## DEVELOPMENT REVIEW COMMITTEE

February 20, 2023

### 580 BRINY AVENUE APARTMENTS – Site Plan

**Request:** Major Site Plan  
**P&Z Number:** 22-12000043  
**Owner:** Claridge Homes Beachboys LP  
**Project Location:** 580 Briny Avenue  
**Folio Number:** 494306060260  
**Land Use Designation:** Medium-High (MH 16-25 DU/Acre)  
**Zoning District:** RM-20/AOD (Multiple-Family Residential 20 /Atlantic Overlay District)  
**Commission District:** Andrea McGee (District 1)  
**Agent:** Andrew J. Schein  
**Project Planner:** Diego Guevara (954-786-4310 [diego.guevara@copbfl.com](mailto:diego.guevara@copbfl.com))

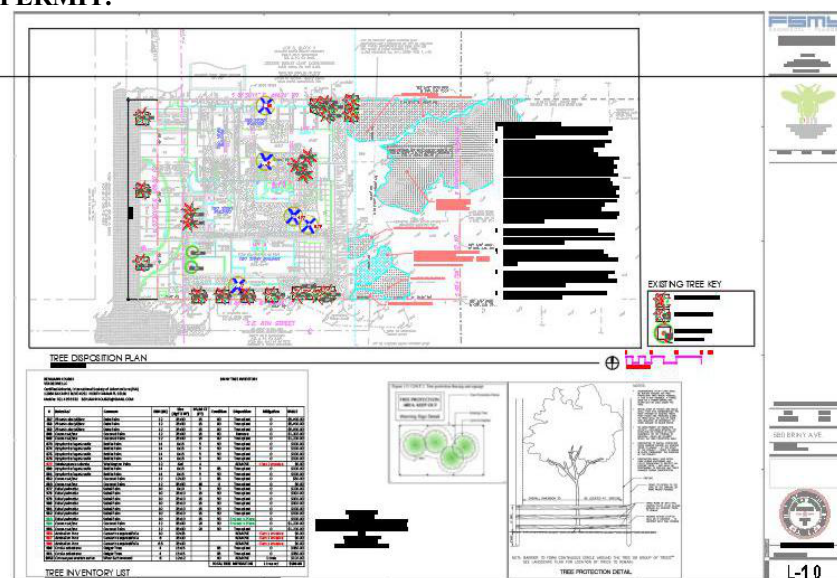
10. Pursuant to Code Section 155.5203.B.2.g.ii(A)(2) & 155.5203.B.2.g.ii(D)(2): Based on the height of the new building, half of all required canopy trees are to be 16' tall and palms to be 22' OA. Adjust the heights on the plant list in accordance with the referenced code section.

**RESPONSE: Heights of all shade trees and palms adjusted. Understory tree may have issues reaching height and have little to no availability.**

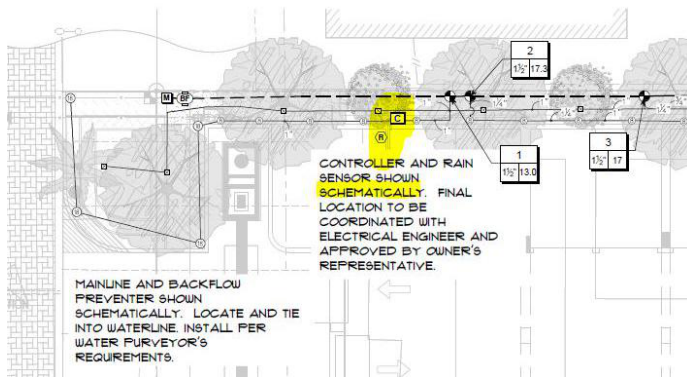
44. Staff requirement: Provide medium canopy trees in parking islands along rear drive aisle.

**RESPONSE: Silver Buttonwood(4) provided in parking island.**
